TO: District of Columbia Zoning Commission

FROM: *JLS*
Jennifer Steingasser, Deputy Director, Development Review & Historic Preservation

DATE: May 15, 2017

SUBJECT: ZC 16-24 - Hearing Report — Consolidated PUD and Related Map Amendment at 1336 8th Street, N.W. (Square 399, Lot 68)

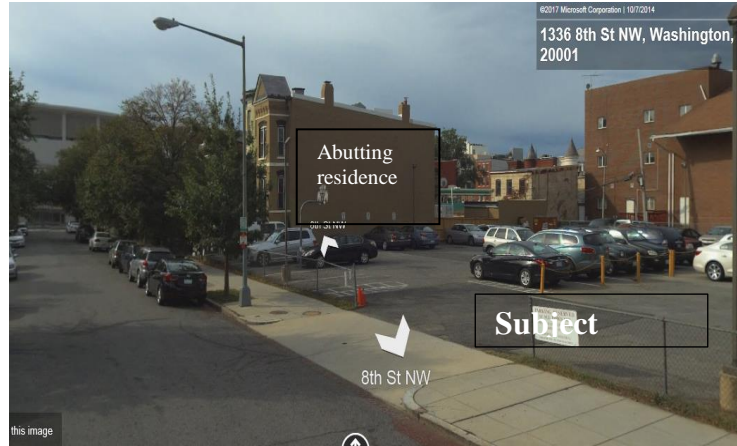
2. Loading: C § 902: one 30 foot berth for all uses, without a 200 square foot platform which is required for residential use;

All parking and loading would be entered off of the north-south alley to the west of the property. The alley’s effective width would be increased from 10 to 15 feet by the building’s rear yard. According to the applicant’s Comprehensive Transportation Review (CTR), the amount of loading expected is estimated as follows:

The CTR estimates that the proposed development is expected to generate 5 to 6 truck trips per day and the loading berth that would be provided should be sufficient to accommodate the projected demand. Truck routing to and from the site will be focused on 9th Street and 7th Street, which are DDOT designated primary truck routes. The addition of the 5-foot set easement proposed in the alley is expected to provide additional space for trucks to maneuver safely in and out of the site. OP has no objection to the requested relief to not provide an additional loading

area and a platform, subject to DDOT's confirmation that the loading assumptions and deliveries are satisfactory.
